STATE OF MICHIGAN
DEPARTMENT OF ENVIRONMENTAL QUALITY
LANSING

August 20, 2009

SUBJECT: G&H Landfill Superfund Site, Review of January – July 2008 Report

**Chart 7: Slurry Wall Inward Gradient Summary at GH-80/GH-81
G&H Landfill Superfund Site, Utica, MI**

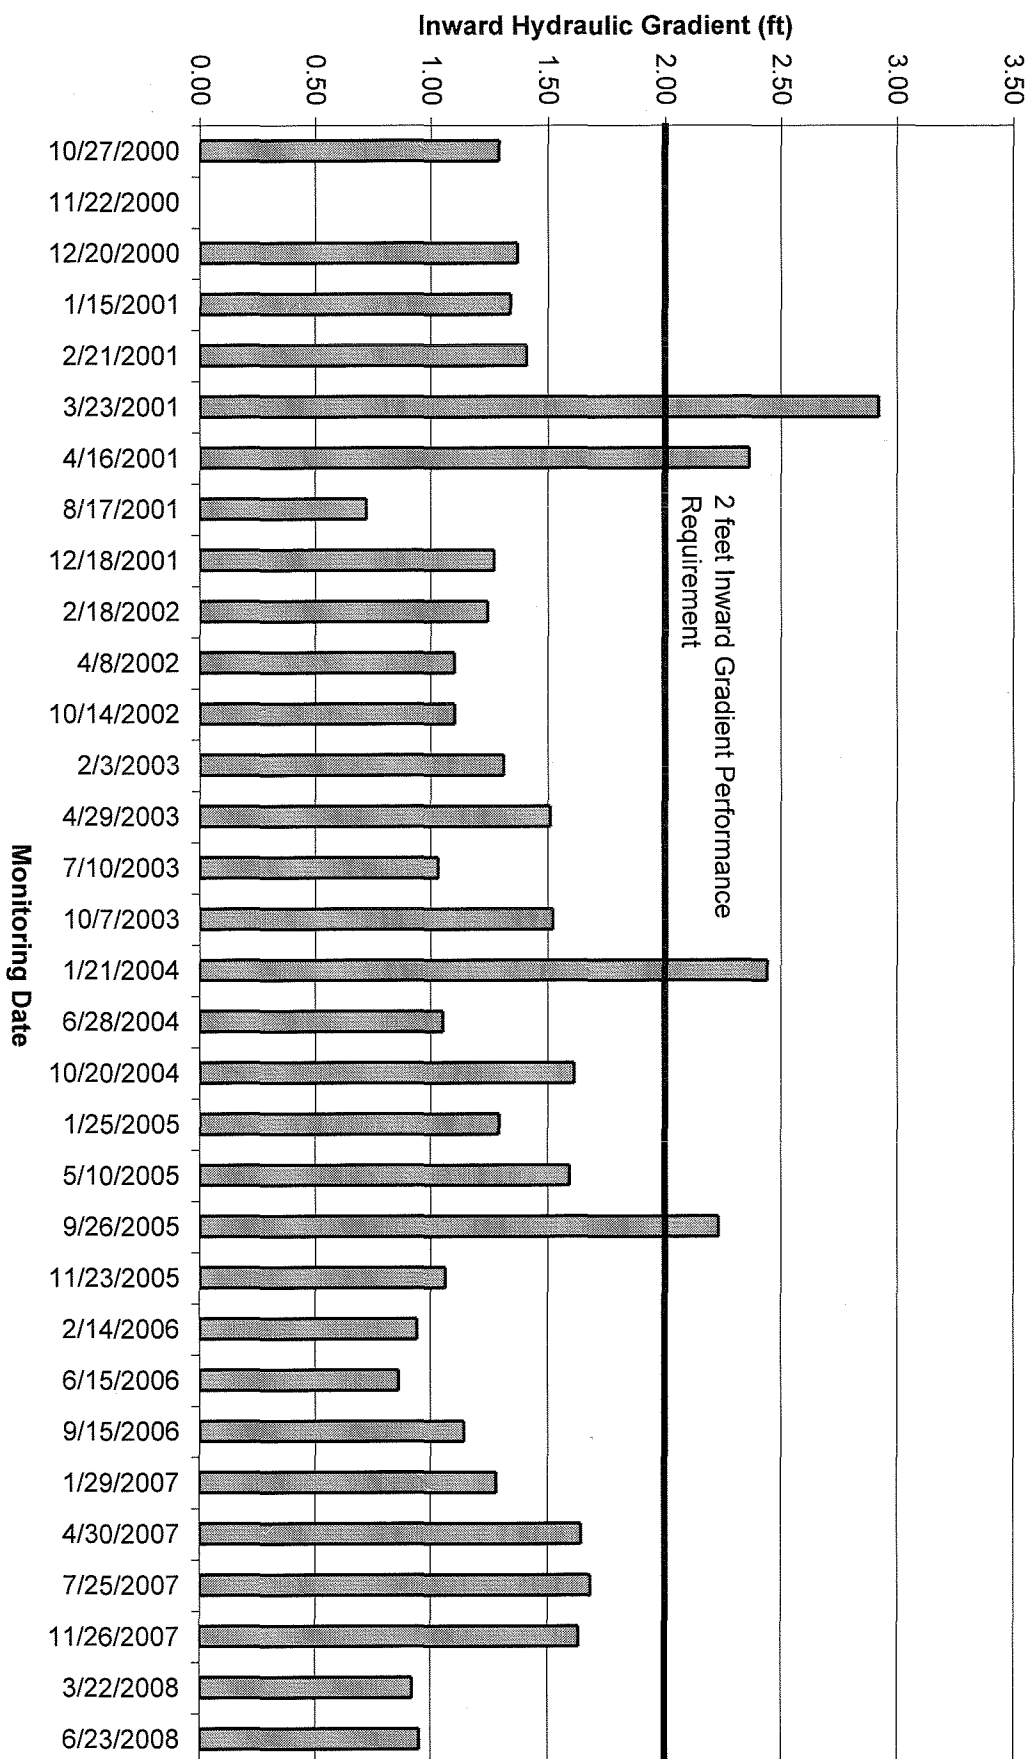
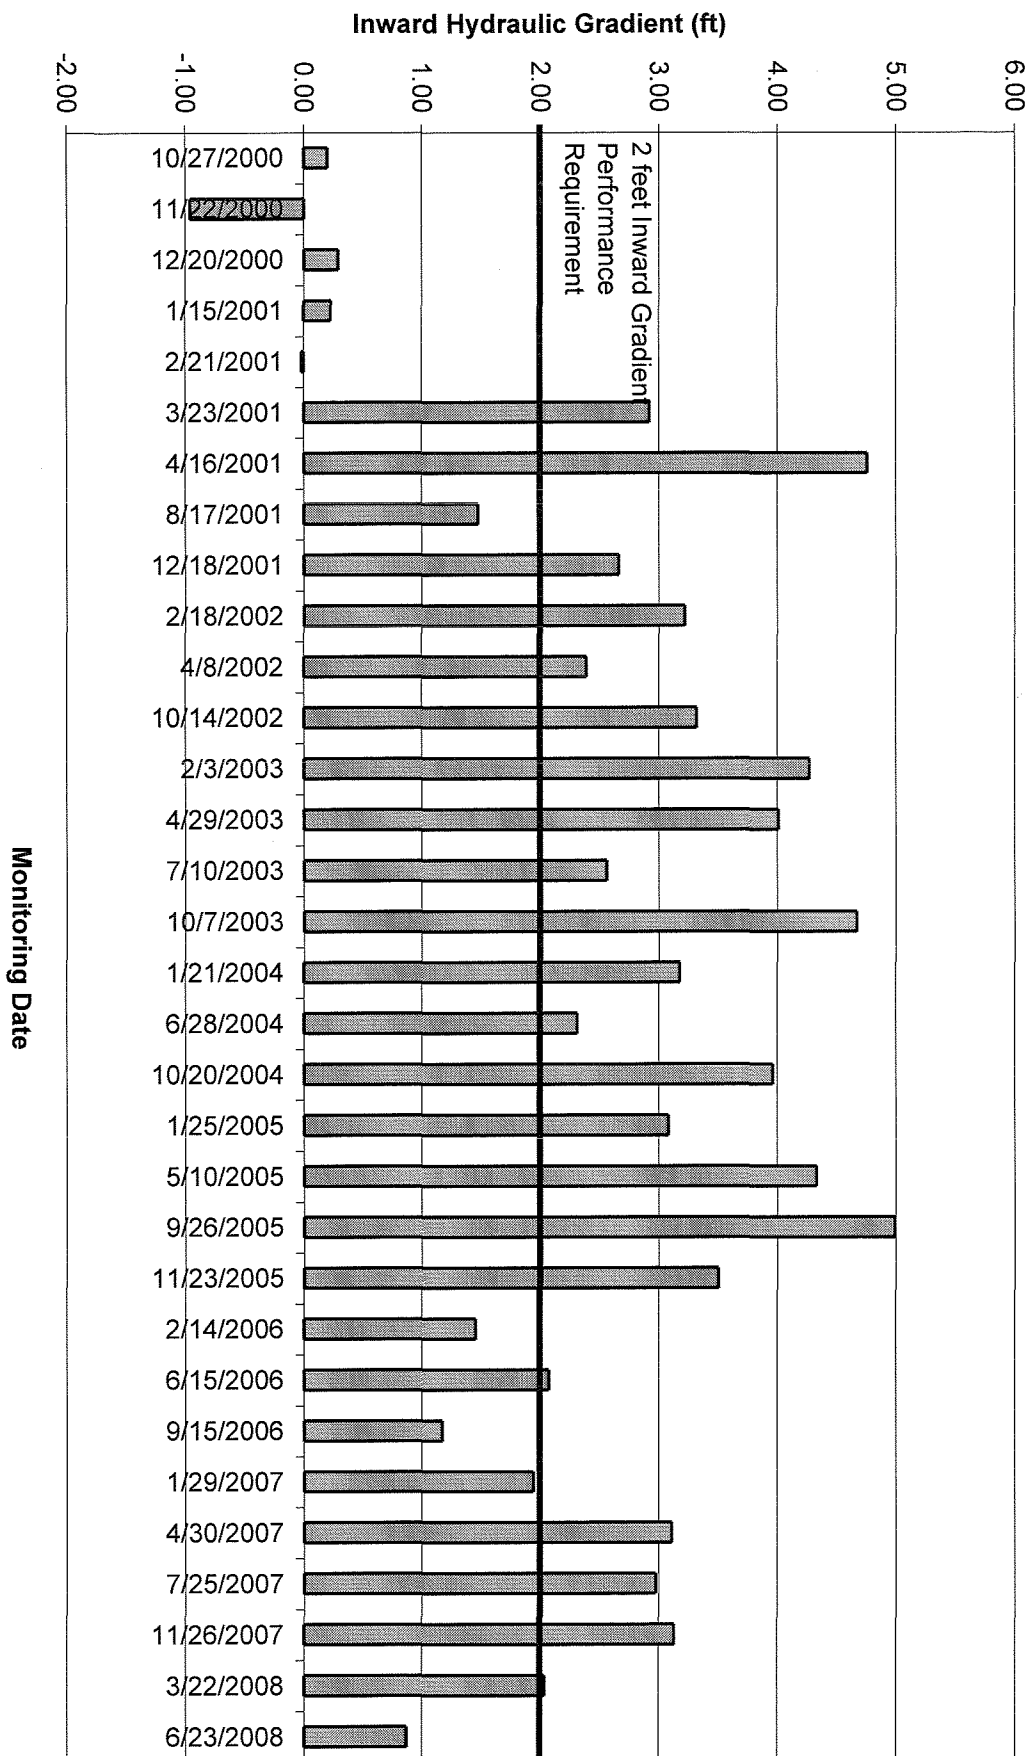
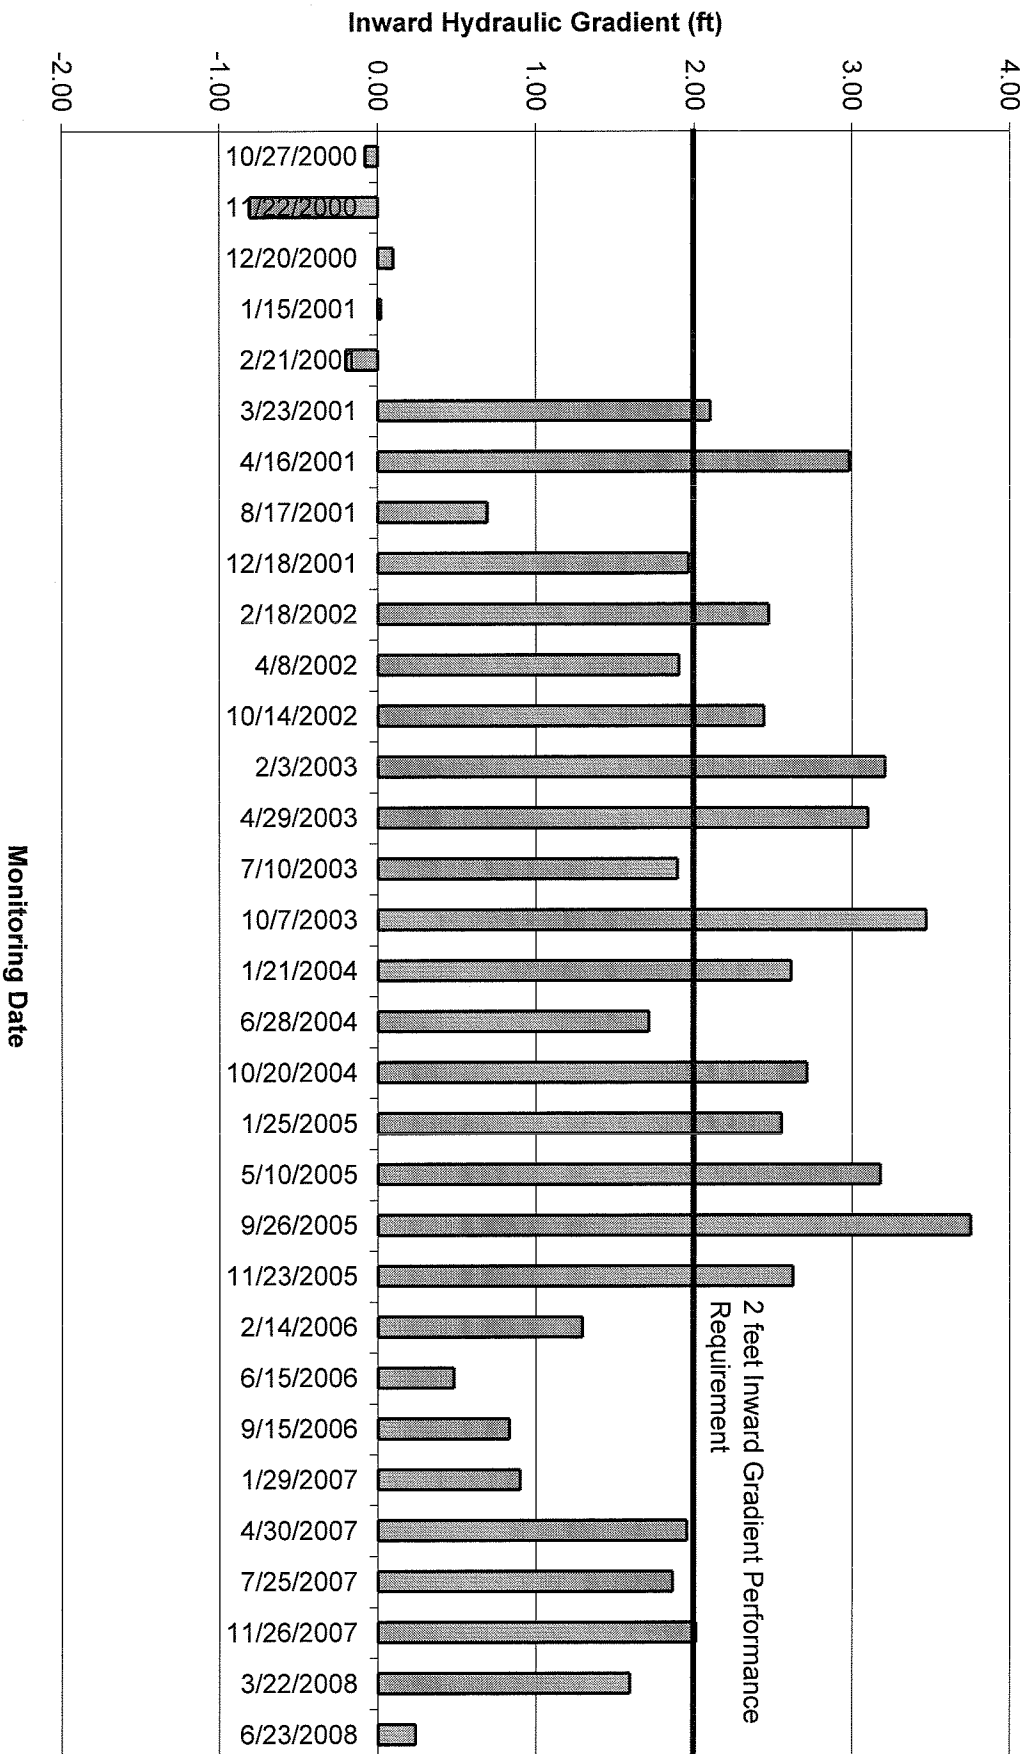
The inward gradient achieved across the slurry wall, during the past 8 years of operation, was evaluated by the MDEQ by comparing the inward gradient achieved (expressed in feet) over time at the internal/external monitoring well pairs along the slurry wall. Results of that evaluation are attached to this letter (Attachment A, Charts 1 - 8). The charts illustrate that the 2.0 feet inward gradient:

- Has been achieved and maintained at the GH-56/57 pair;
- Has been initially achieved and maintained, but has been lost in recent years at pairs GH-60/61, GH-80/81, and GH-82/83; and
- Has rarely been achieved at pairs GH-52/53, GH-54/55, GH-58/59, and GH-78/79.

Charts 1 through 8 also show that an outward gradient occurred frequently at pair GH-52/53 and occurred at pair GH-58/59 for most of 2007.

- Implement the approved corrective action plan to achieve hydraulic and physical containment of the source areas;
- Execute contingency plans to achieve the 2-feet inward gradient at the barrier wall and maintain water levels to allow the collection of NAPL from the Phase I and Phase II landfill cells as required in the SOW;
